RESULT OF VOTING ON CDV

80/227/CDV

Project: IEC 60872-3 Ed.1

Draft IEC 60872-3: Maritime navigation and radiocommunication equipment and systems - Radar plotting aids - Part 3: Electronic plotting aid (EPA) - Performance requirements - Methods of testing and required test results

Proposal from Germany - Scenarios - Annex B

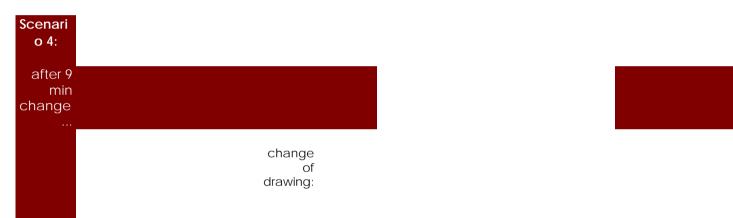
National Committee		Paragraph Figure/ Table	Type of comment (General/ Technical/Editoria l)	COMMENTS	Proposed change	OBSERVATIONS OF THE SECRETARIAT on each comment submitted
Japan	all scenario tables.		editorial	Time (s) in	Change (s) to (min).	Agreed.
Germany	4.2.3 Annex B		Technical	The scenarios 5 and 6 given in annex B of the standard give incorrect results in plot intervals 4 (scenario 5) and 6 (scenario 6) with some correctly implemented EPA's. The reason is the inclusion of own ship and target data changes at a time between plot intervals.	4.2.3 Method of measurement: add as 3. sentence: Required own ship changes has to be performed at the beginning of the interval (immediately after the last plot has been set).	
				To avoid this, these intra-plot stages given in the scenarios should be discarded (to keep scenarios congruent in all scenarios).	annex of this mail	It is noted that all scenarios have changed, not just 5 and 6. NOTE BY THE SECRETARY TC 80 –

In this case own ship changes has to be performed at the beginning of the interval (immediately after the last plot has been set).		Although these proposals arrived after the close of voting, they have all been accepted. The reasons for change have been unanimously agreed by the Working Group.
